HG1 KS3 LAND AT READERS WAY, RHOOSE

Increased flood risk fails the requirements of TAN15

Photographs of historic run-off flooding and highway flooding at Fontygary Inn traffic lights. Previously forwarded, with others to [REDACTED] at their request.

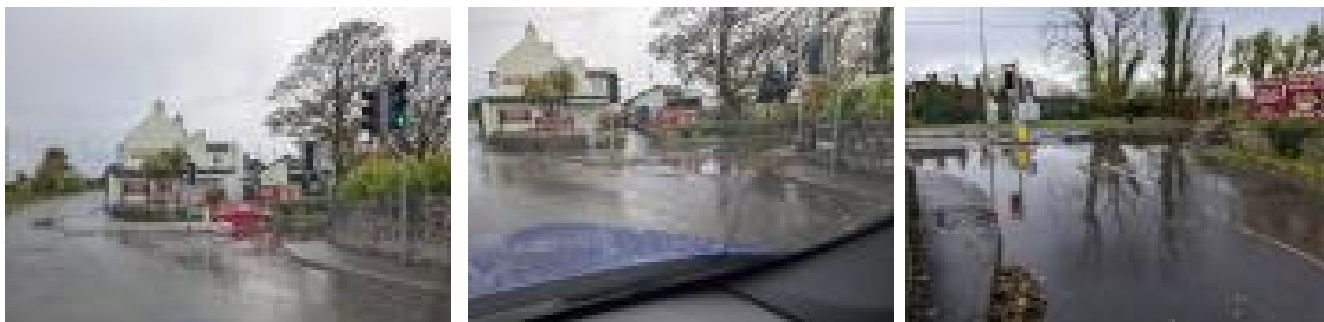
Flooding at Fontygary Inn traffic lights 19.11.24, The access into Fontygary Leisure Park was also flooded, preventing access. I have no photographs of that.

Run off showing mud content which leaves a muddy slurry all over Celtic Way creating a slip hazard.

Run-off is usually over prolonged periods. This time overnight and through the following day. Essentially every time it rains. This is a regular occurrence – 12 times since Christmas and over the 35 years we've lived here
